Request to the Planning Assessment Commission

Watermark Coal Project

**QUESTIONS RELATING TO GROUNDWATER IMPACT ASSESSMENTS
WATERMARK PROJECT**

Figure 3: Vertical section model illustrating the water table after 1000 days for the nominated van Genuchten parameters

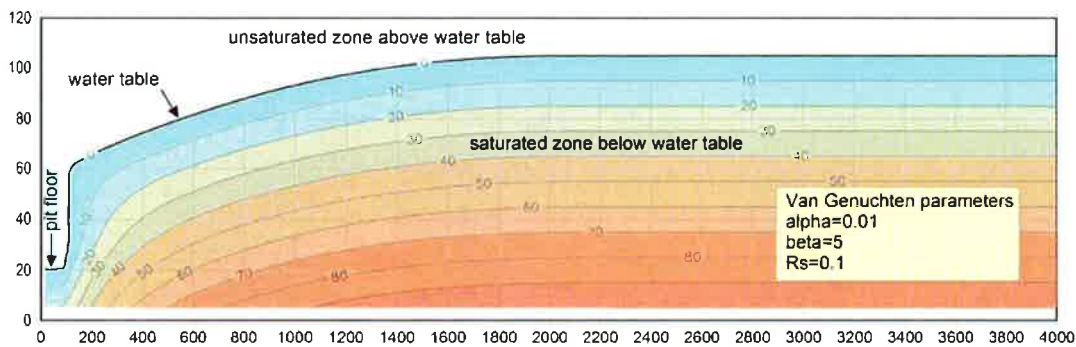
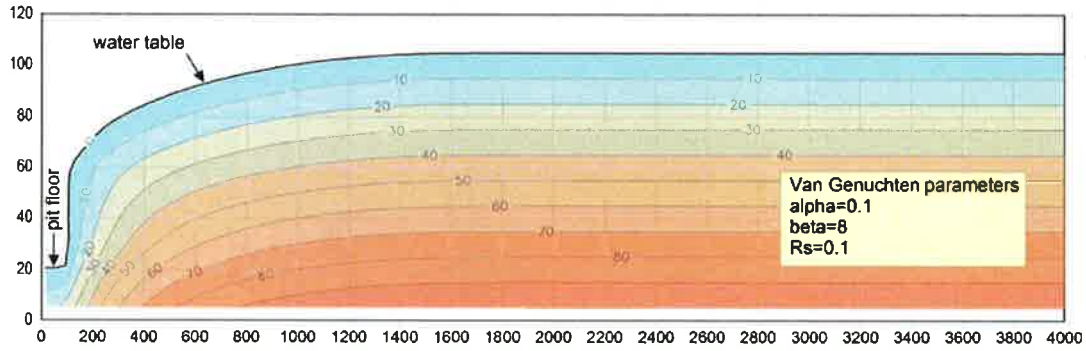
This perspective conflicts with the commonly held view that both saturated and unsaturated zone properties can influence to varying degrees, the calculation of the water table at any location in a groundwater model which is not a prescribed head boundary condition. By way of example, Figure 3 illustrates a simple vertical section Modflow Surfact model with saturated flow parameters in a broadly similar range as the Watermark model and unsaturated flow parameters identical to that model. A pre-mining water table has been uniformly set at an elevation of 110 m and a mine pit with a minimum elevation of 20 m has been represented by 'drain' cells at the left end of the section. A pore pressure distribution (contours in metres pressure head of water) has been calculated at 1000 days after commencement of mining. Figure 3 shows the water table defined by the zero pore pressure contour rising steadily away from the pit.

Figure 4 shows the same saturated zone parameterisation but with different van Genuchten parameters applied to the unsaturated zone. Clearly the zone near the mine pit shows a different water table geometry to Figure 3 indicating that the water table is influenced in this case by the van Genuchten parameters.

In support of the adopted van Genuchten parameters and in response to questions put, the proponent has indicated that *'the drain boundary condition is the dominant influence on the simulated water levels, not the unsaturated zone parameters. It is only relatively distant from the drains cells representing mining that the influence of the hydraulic parameters becomes more influential on the predicted water level'*³.

Figure 5: Cross section (left) through a drain cell showing the calculated head ($h_{i,j,k}$) and the reference elevation ($d_{i,j,k}$) from the Modflow reference manual. A vertical column of cells (right) shows the adopted reference elevation in the Watermark model.

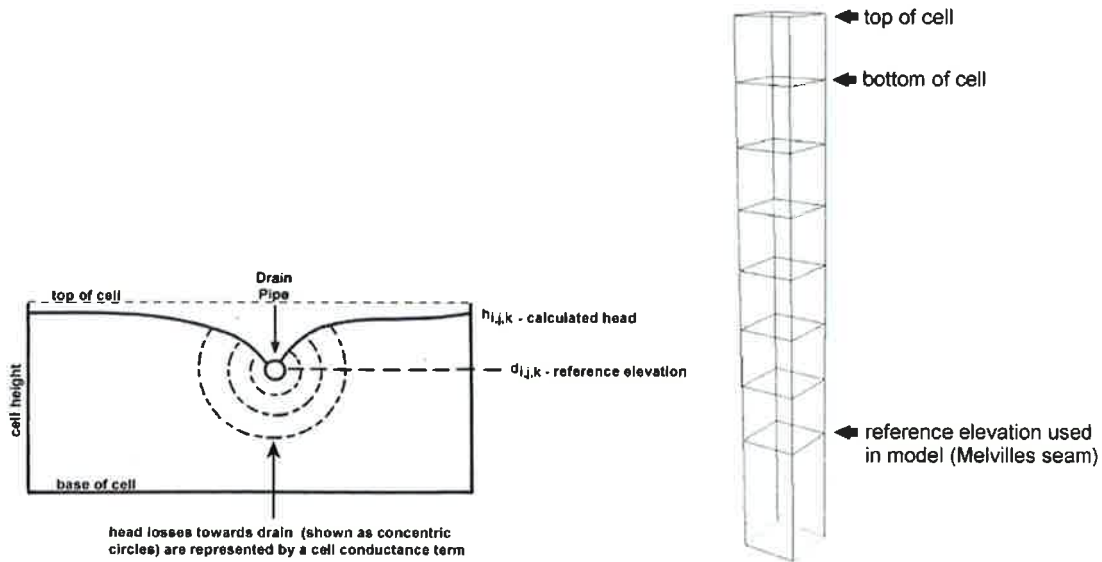
Concern 2: Inspection of the supplied model data files reveals the reference elevations of drain cells within each of the mine pits have been set to the lowest drain cell (layer 10 - Melvilles seam) of a vertical column of cells. That is, for all drain cells above layer 10, the reference elevation is below the base of the cells. This is an unconventional use of drain reference elevations that may lead to quite different outcomes in either the calculated heads or the volumetric balances of the model, or both when compared to the conventional assignment of drain elevations. The conventional procedure requires the reference elevation to be set at or above the bottom of the cell in which a drain boundary is specified. Indeed the popular Graphical User Interfaces (GUI)⁴ for Modflow Surfact normally warn the user if the reference elevation is set below the base of the cell.

Figure 6: EIS Mining model provided by the proponent showing the vertical pore pressure distribution

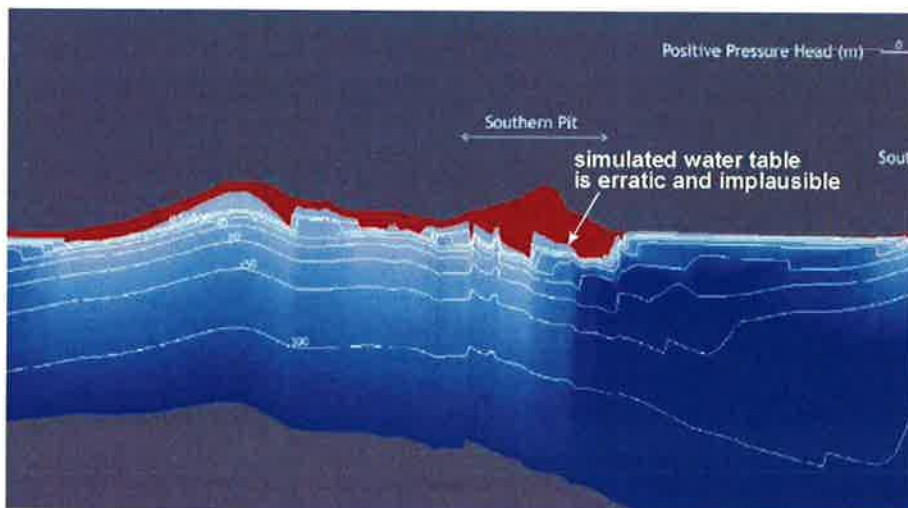
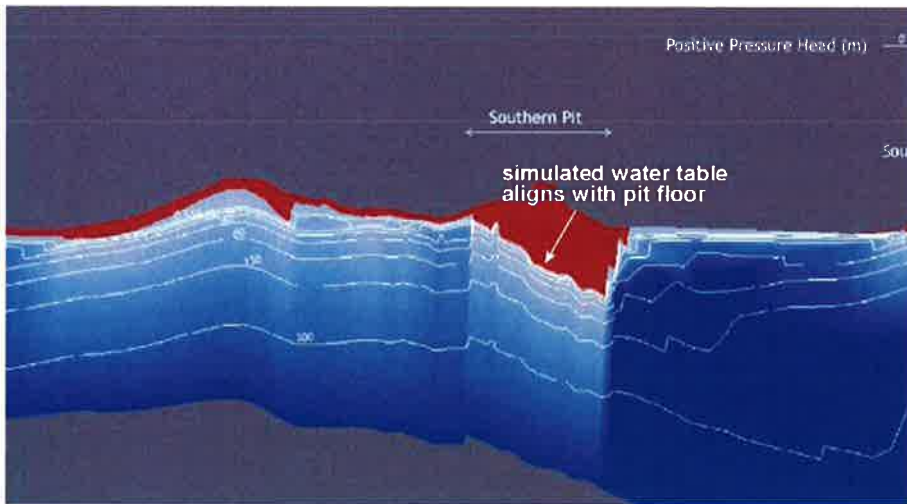
Concern 3: Figure 6 represents the EIS model with pore pressures indicated by the white contours. Close inspection of the zero pore pressure (water table) contour in the Southern Pit shows a highly erratic surface. Normally a relatively smooth surface that reflects the floor of the mined coal seam, would be expected (see Figure 7 for dewatered pit profile). The erratic surface identified in Figure 6 may be indicative of more general problems possibly associated with recharge to spoils, or to unconventional assignment of drain cells or possibly discretisation issues. It is important to identify the reason for this behaviour since it may have implications for regional water table drawdown and mine water inflows.

Figure 8: Pit inflows generated by WST model showing highly erratic behaviour. Note the simultaneous occurrence of inflow 'pulses' across all three pits (red arrows).

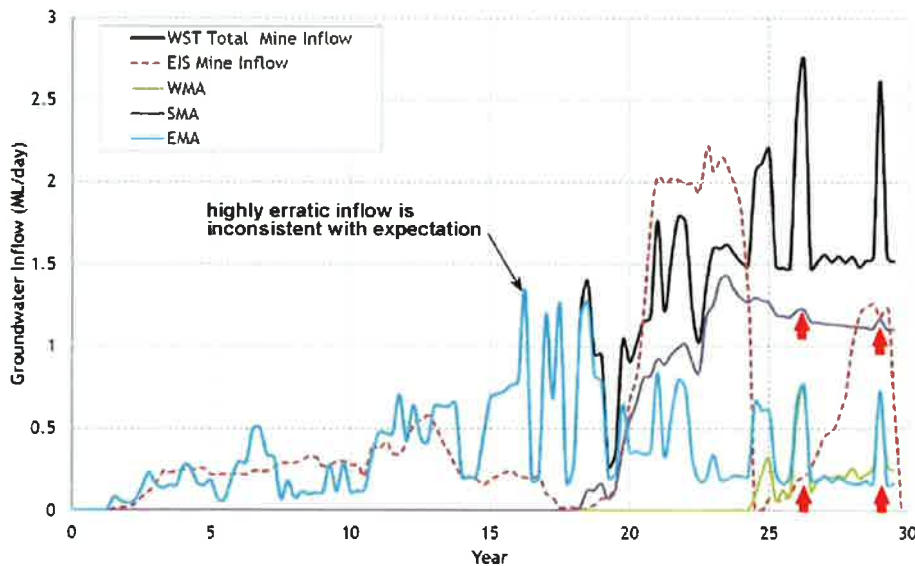
Concern 4: While the EIS model inflows exhibit a relatively smooth trend line, the same cannot be said for the WST model where highly erratic behaviour is evident for the Eastern and Western pits. This erratic behaviour includes correlatable 'spikes' in the inflows across all three pits simultaneously (red arrows) suggesting underlying instability or abnormal behaviour in the model which needs to be resolved.

Figure 10: Water table recovery trend at R92/C69 extracted from the supplied recovery model HDS file

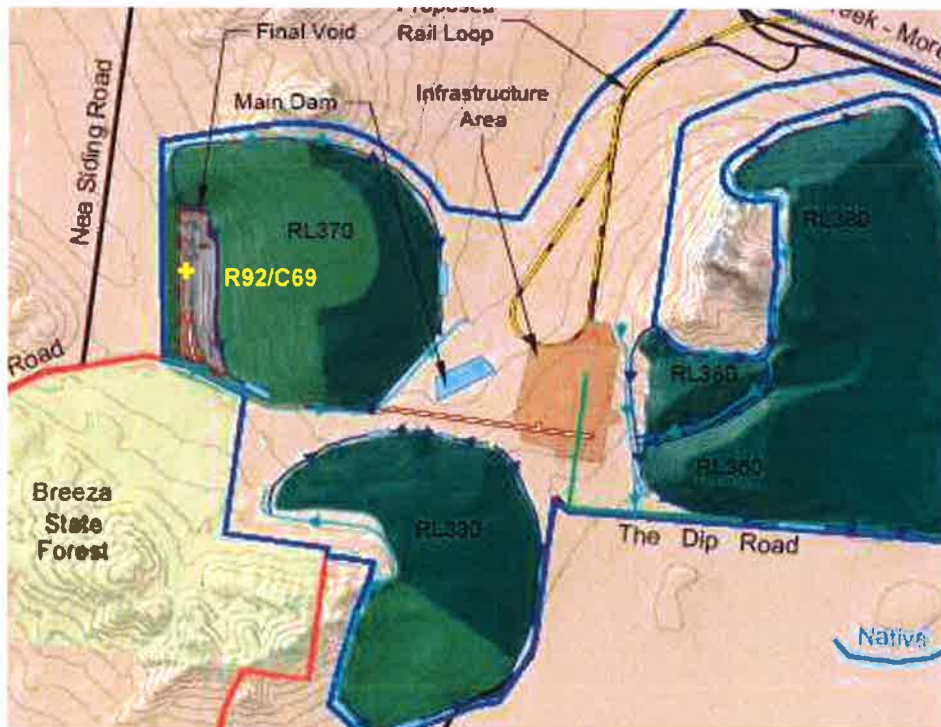
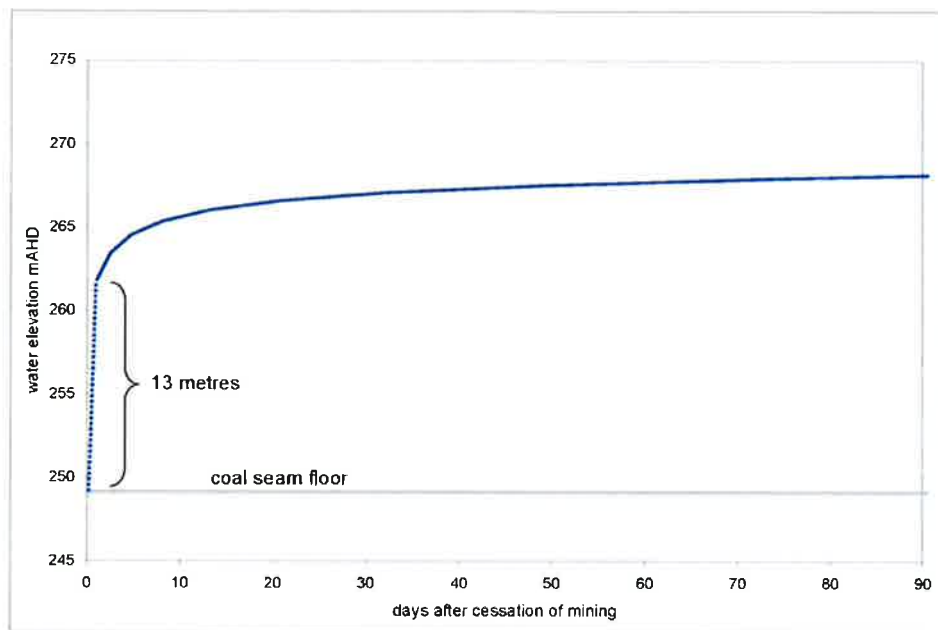
Comment 6 - Interrogation of the recovery phase of the reported model at selected model cells located within West pit indicates rates of water table recovery that seem implausible. For example, the recovery response at the model cell located at the intersection of row 92 and column 69 (see Figure 1 below) indicates just 1 day into the recovery phase, a water table elevation that is about 13 m above the pit floor (see Figure 2 below).

Question 6a: What are the model factors that promote this extraordinarily rapid recovery?

Figure 2: Water table recovery trend at R92/C69 extracted from the supplied recovery model HDS file

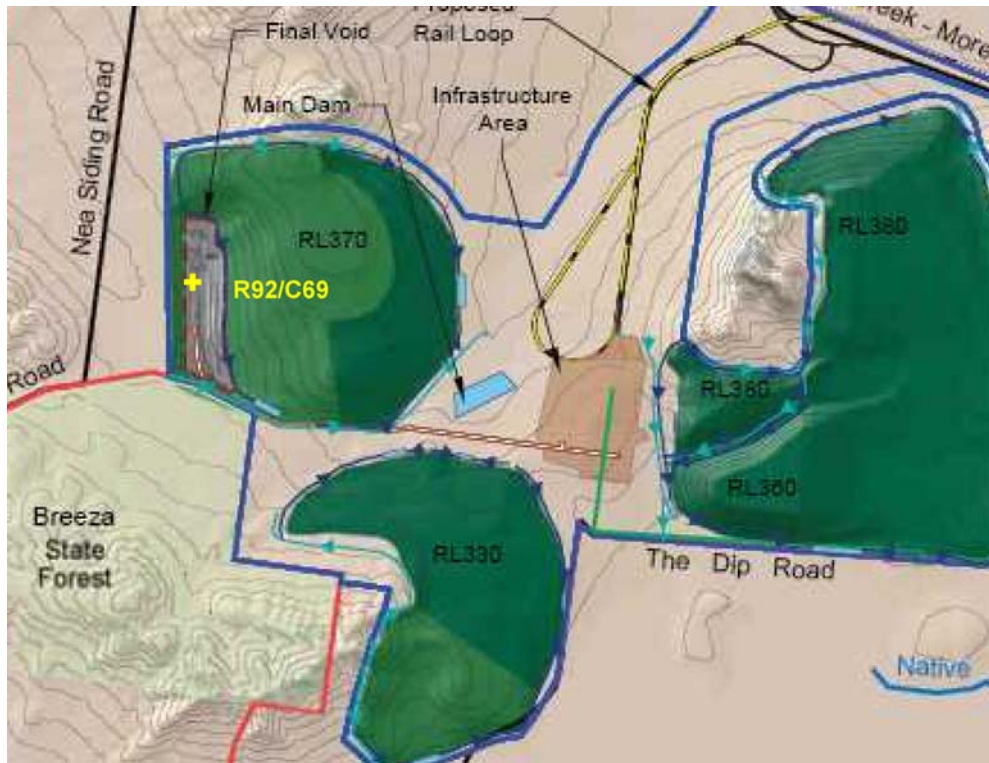
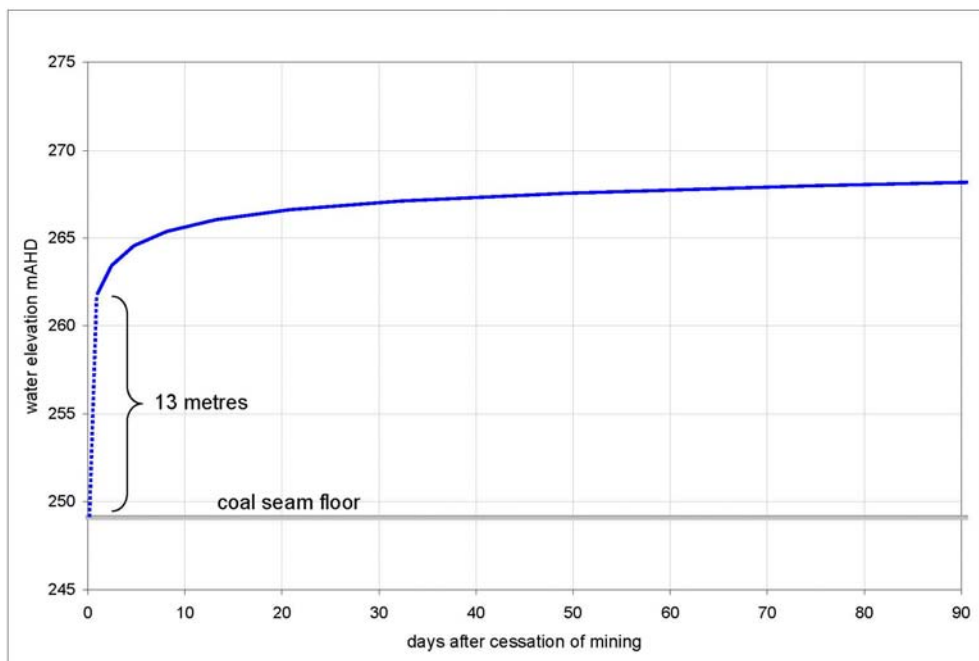
Comment 6 - Interrogation of the recovery phase of the reported model at selected model cells located within West pit indicates rates of water table recovery that seem implausible. For example, the recovery response at the model cell located at the intersection of row 92 and column 69 (see Figure 1 below) indicates just 1 day into the recovery phase, a water table elevation that is about 13 m above the pit floor (see Figure 2 below).

The rapid recovery simulated by the model at cell R92/C69 is due to a number of factors. The figure below shows the water levels recorded in this cell prior to, and at the end of mining and assists in explaining the response.

The drains cells are active on this cell for a period of one year, then are turned off for one quarter and the cells properties changed to spoil ($K = 100$ m/day, storage 1) before closure of the mine. During this final quarter, the water level within the cell begins to rebound, as the drains are not active. At the end of mining, there is a small rapid rise in water levels of about 2 m, not 13 m as it appears without the mining stage data. This short rapid rise is considered due to the sudden changes in hydraulic parameters used to represent open void that promote flow from strata surrounding the final void due to the high hydraulic conductivity.

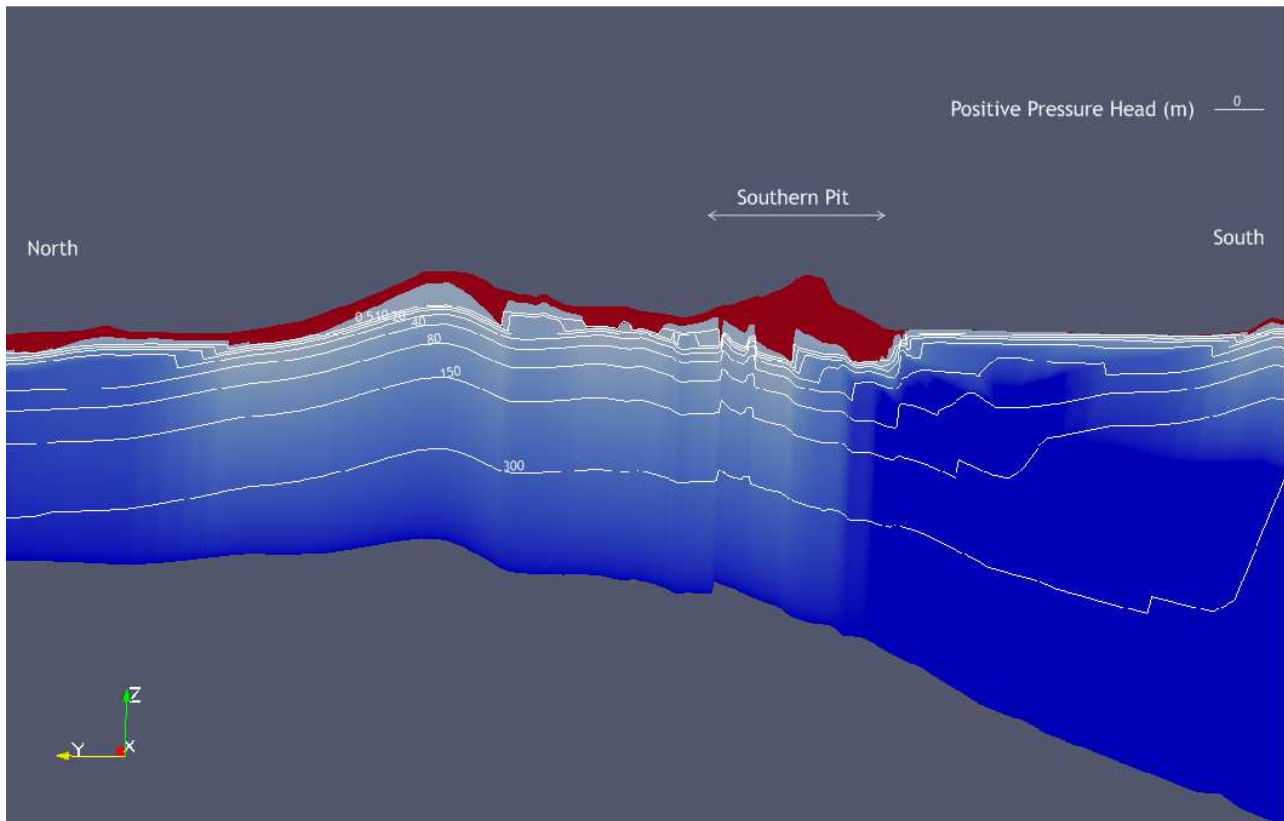
Question 5c: Could the proponent provide a vertical section plot for the reported prediction model at the cessation of all mining, aligned between E245670,N6524200 and E245670,N6548200 (model column 125) and showing zero pore pressure (water table) and all positive pressures as contours?

Answer: The requested section for the EIS model is below.

The red cells are completely unsaturated cells where the simulated water level occurs below the floor of the cell.

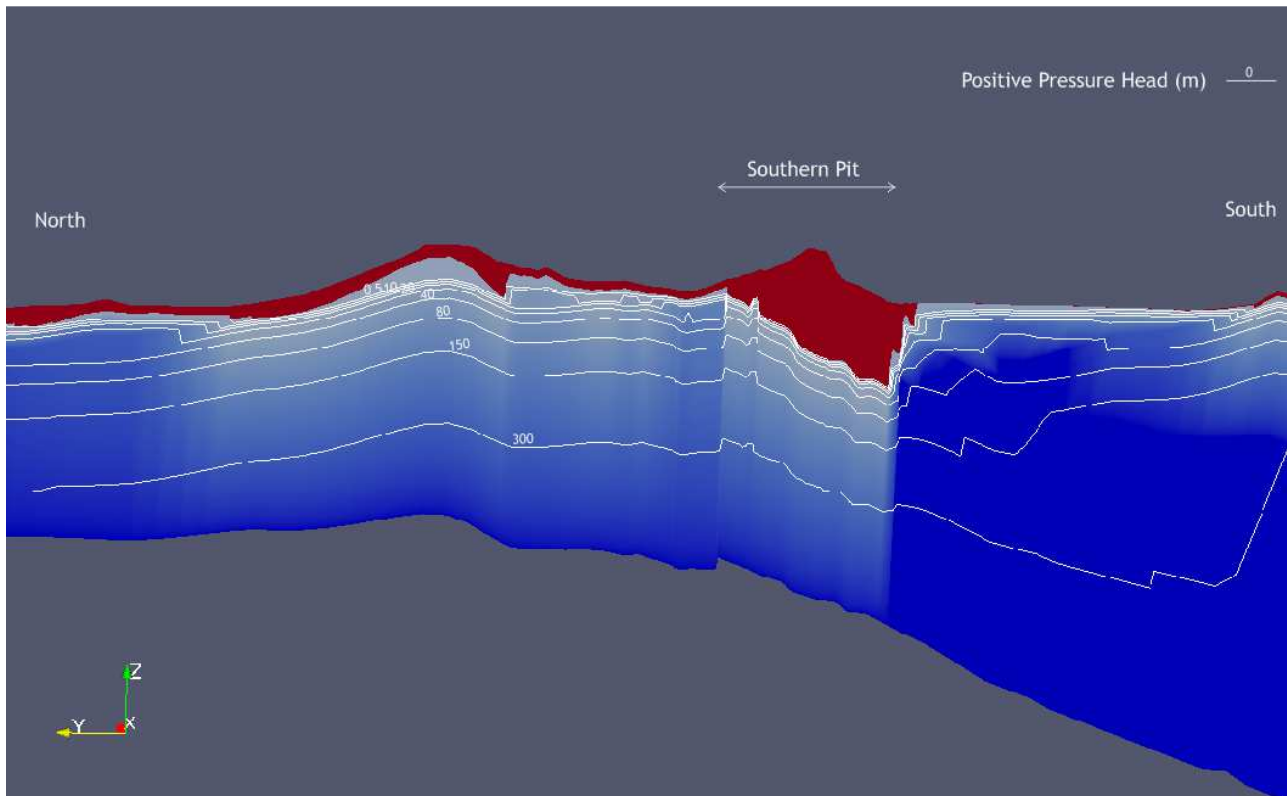
Question 5d: Could the same section be generated for the requested WST simulation model that does not include material property changes (ie continuous simulation), at the cessation of all mining?

Answer: The requested section for the WST model is below.

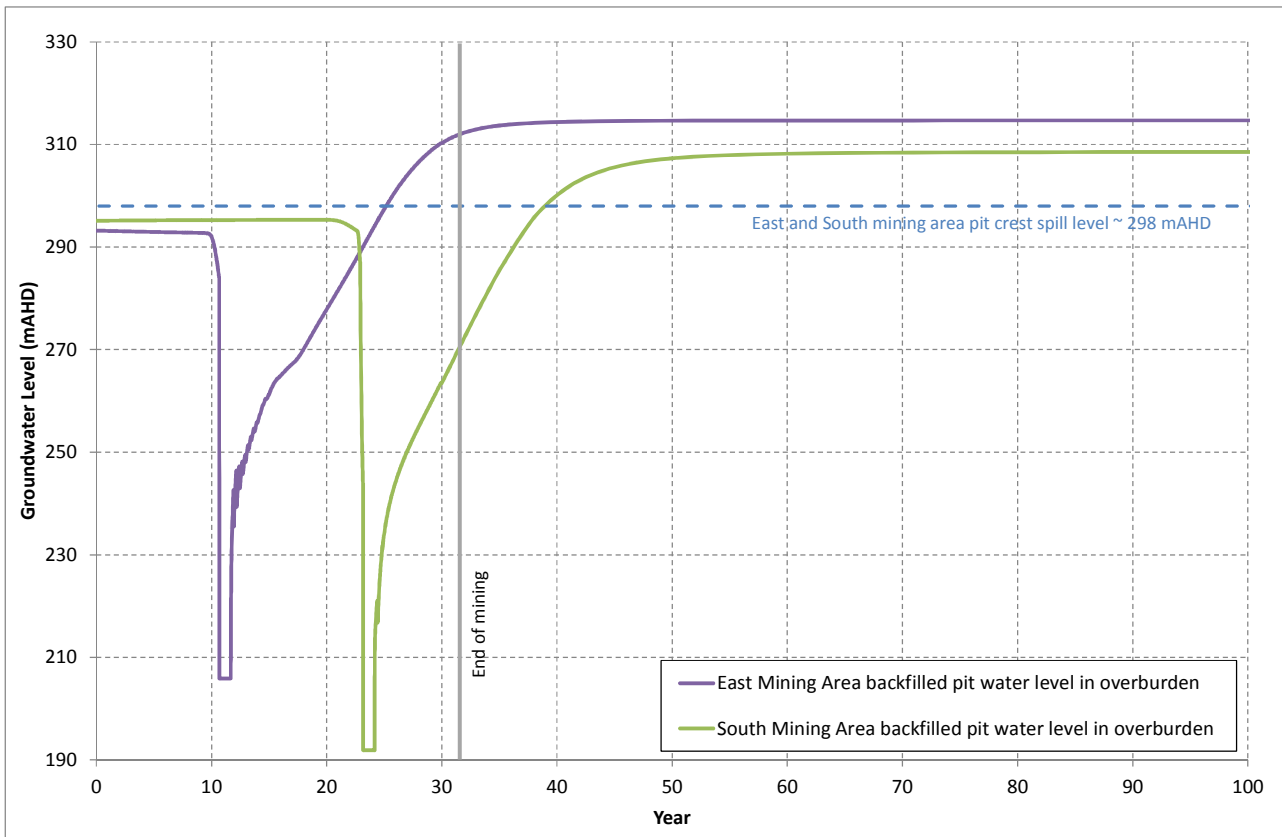
Question 6c: Do similarly rapid recoveries occur in the East and South Pits?

Answer: Recovery within the Eastern and Southern Mining Areas is faster than the open void as the backfilled areas have a lower storage and do not have EVT acting below the 2 m extinction depth. The graph below shows the water level recovery simulated by the EIS model in the Eastern and Southern Mining Areas (source Figure 10.46 from EIS report).

The water level recovery graphs shown are simulated heads at cells R119, C282, and R199,C112. Whilst the graphs show a more rapid rate of recovery immediately following removal of drain cells and backfilling, this is equivalent to about 29 m over 84 days.
